Application Note AN-1113

IRS2301 and IR2301 Comparison

Figures

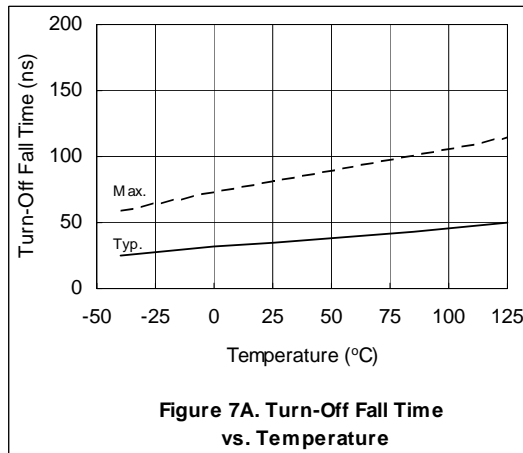
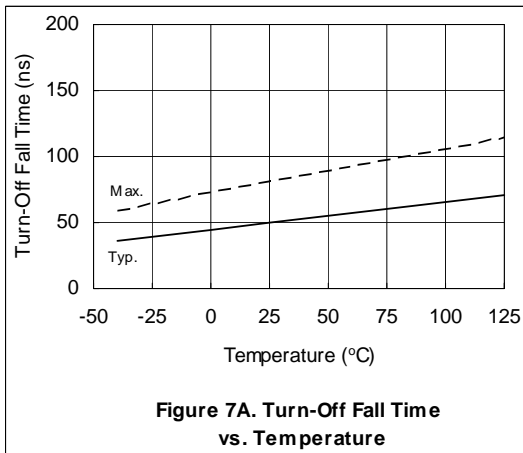
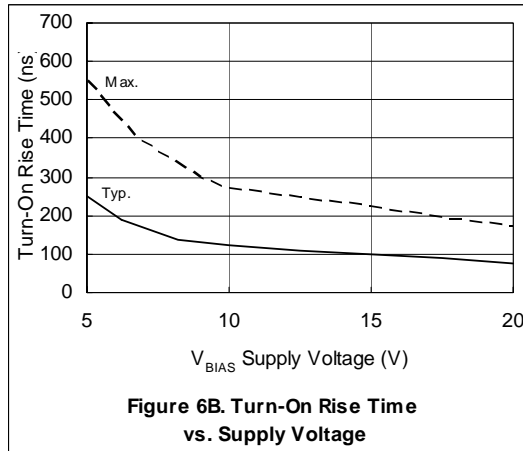
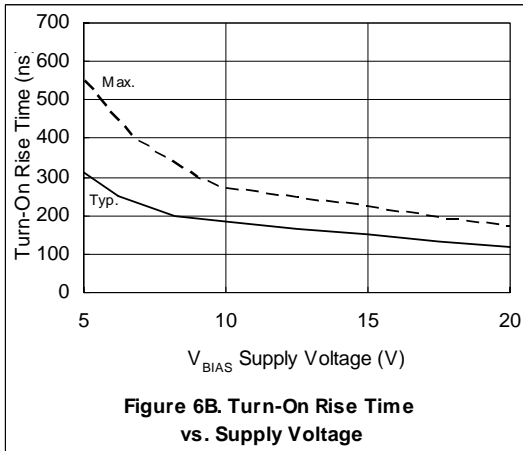
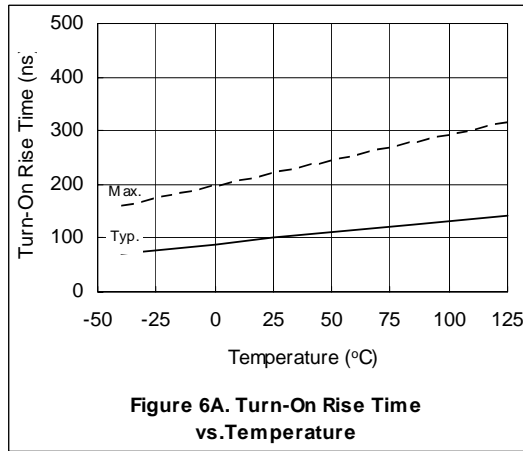
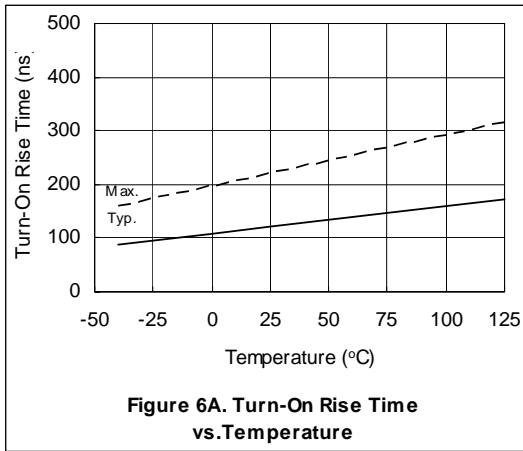
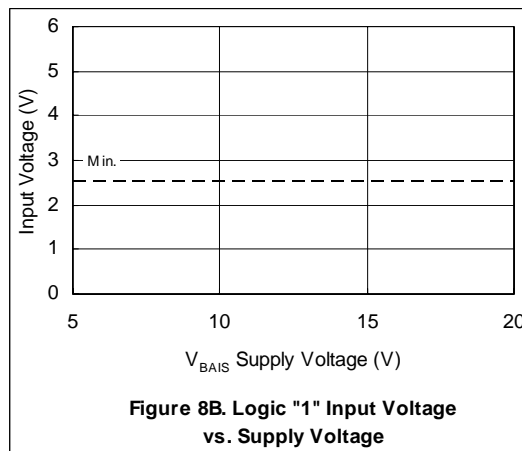
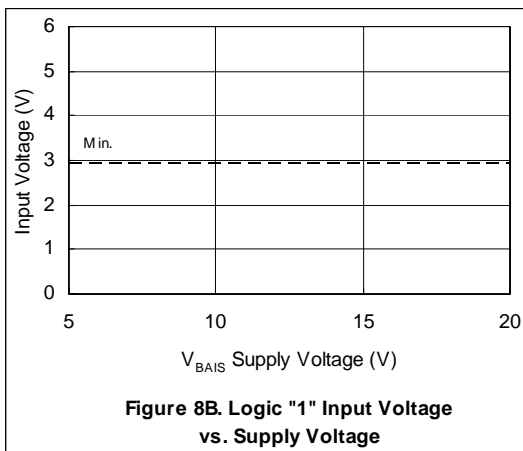
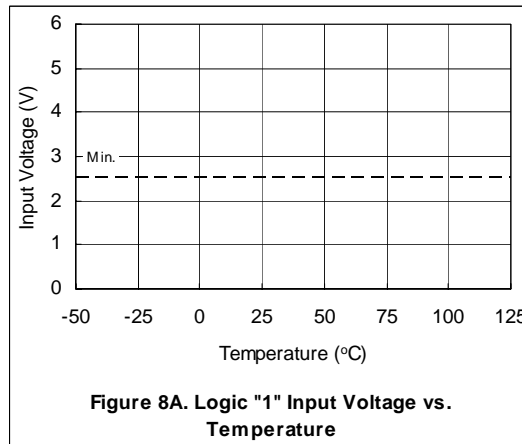
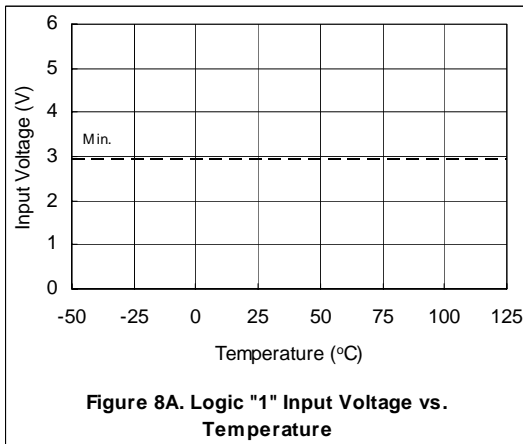
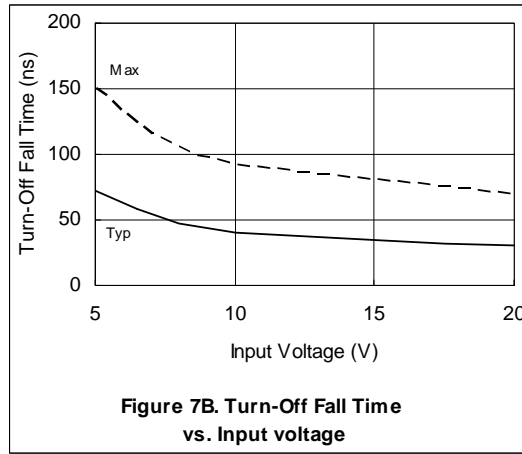
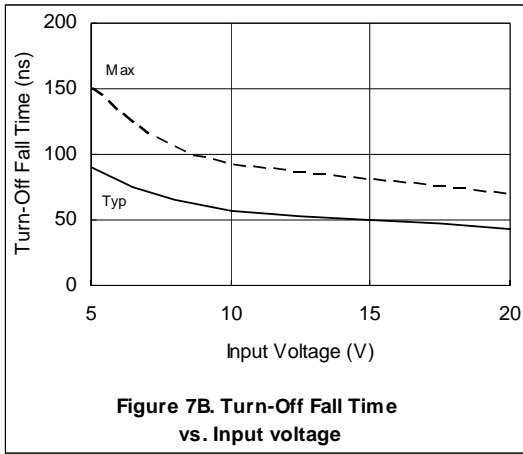
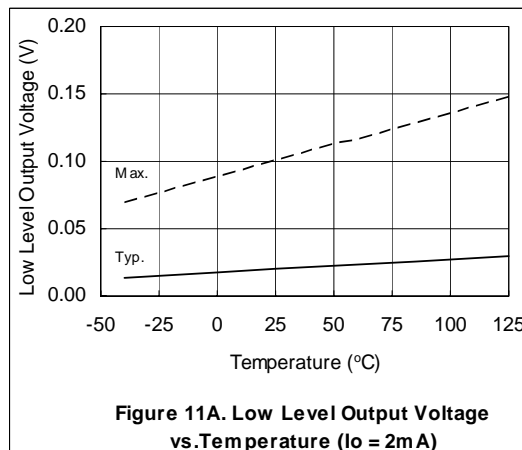
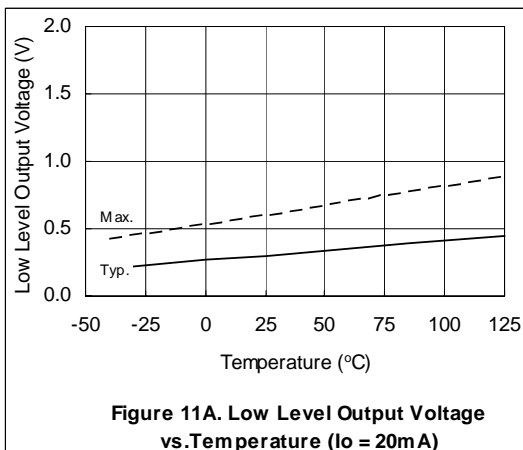
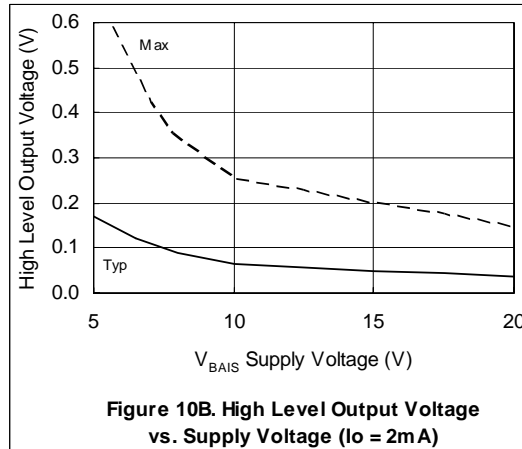
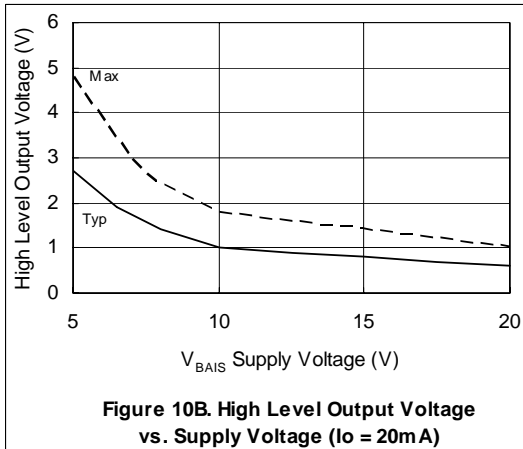
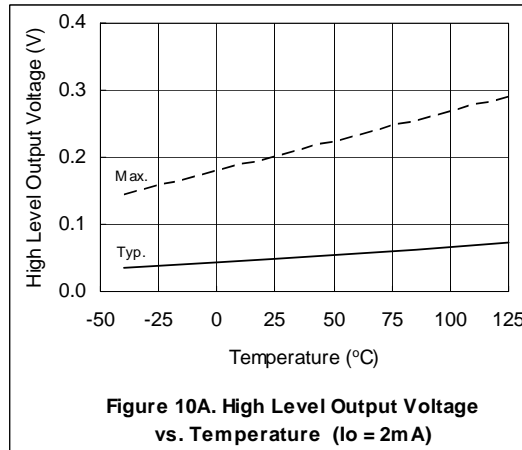
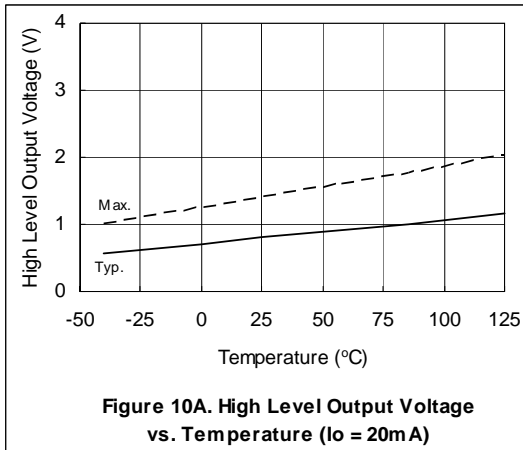
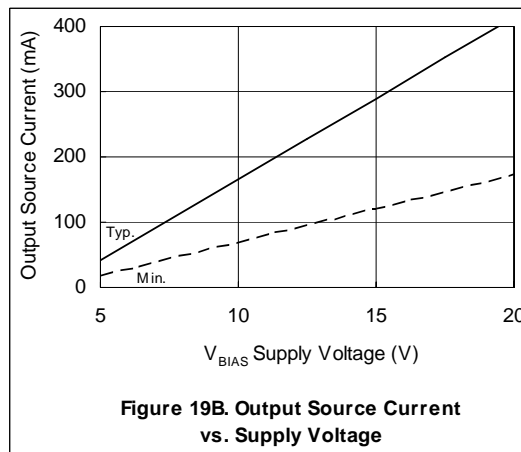
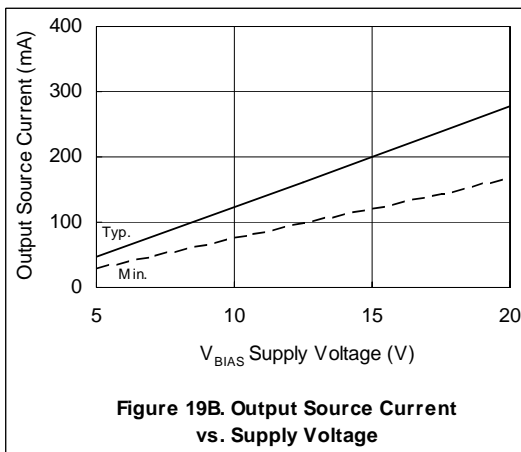
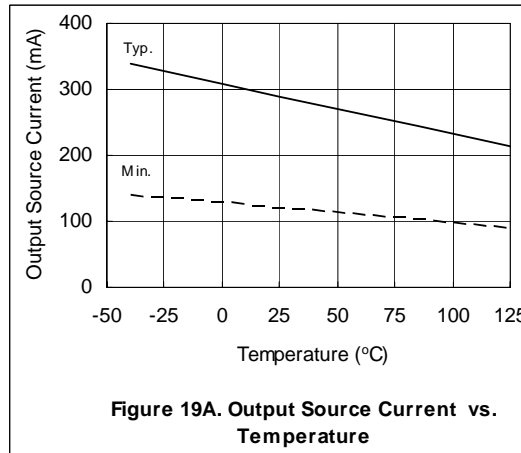
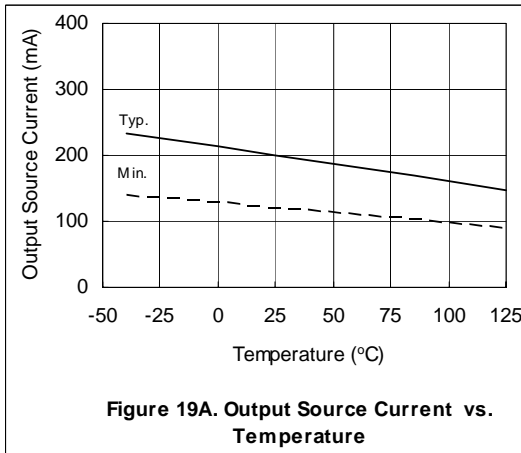
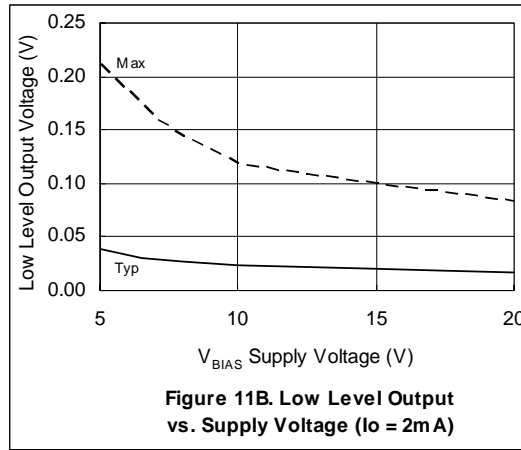
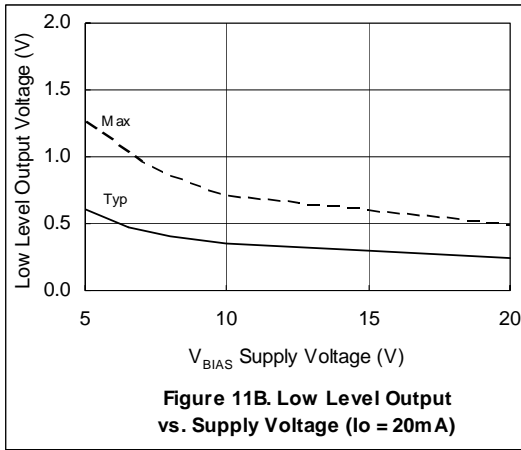
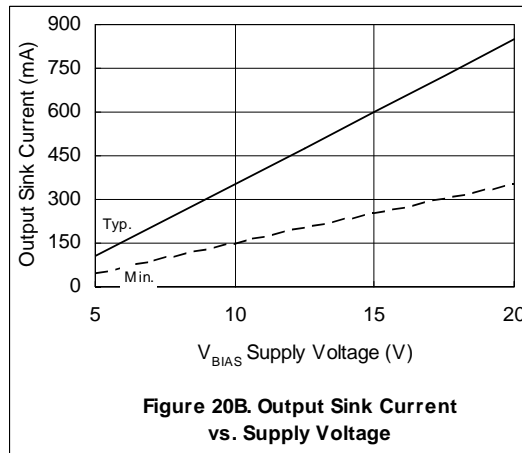
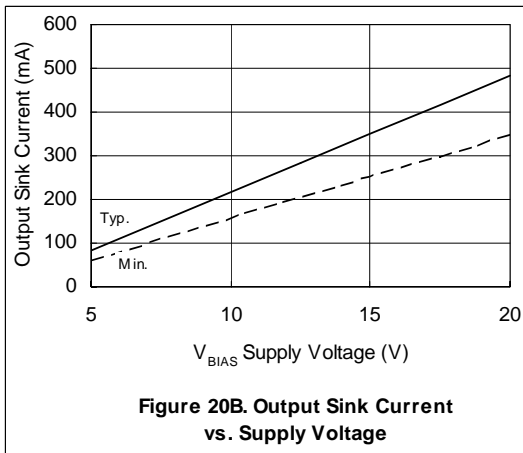
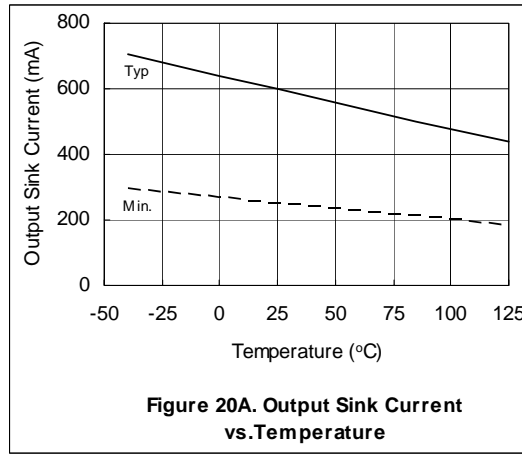
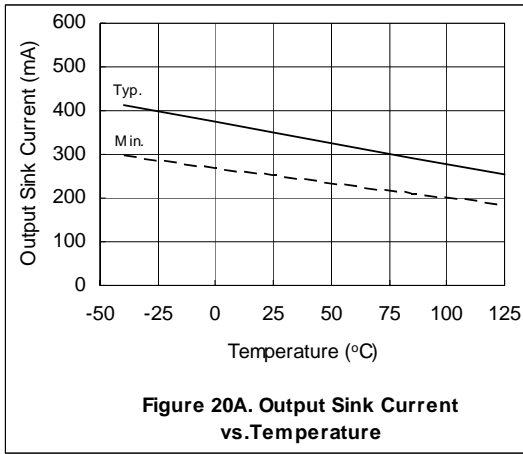
This figures shown in this section compare figures shown in the IR2301 (left column) and IRS2301 (right column) datasheets. Illustrations that have not changed between the two datasheets have not been included in this section.
